REQUEST

Current Zoning: R-22MF (multifamily residential)
Proposed Zoning: UR-2(CD) (urban residential, conditional)

SUMMARY OF PETITION

**STAFF
RECOMMENDATION**

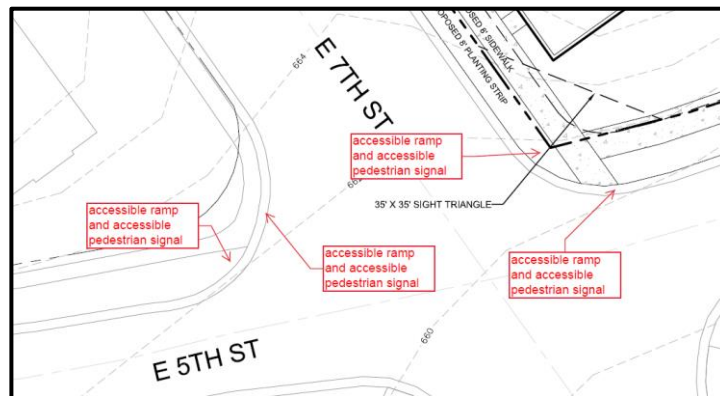
1. The petitioner should revise the site plan and conditional note(s) to commit to construct dual ramps at the corner of E 7th Street and E. 5th Street to meet the City's Charlotte WALKS Policy and PROWAG. In addition, the developer should commit to provide accessible push buttons for its corner. The site plan should label and dimension both items from the back of curb and gutter and road centerline.

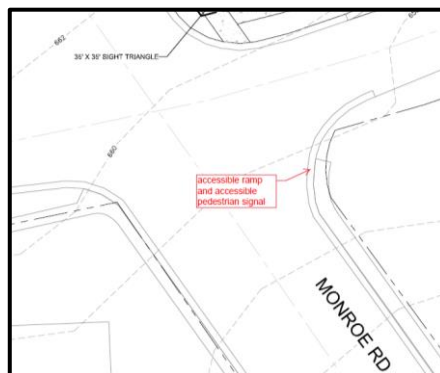
2. The petitioner should revise the site plan and conditional note(s) to commit to construct dual ramps at the corner of Monroe Road and E. 5th Street to meet City's Charlotte WALKS Policy and PROWAG. The site plan should label and dimension both items from the back of curb and gutter and road centerline.
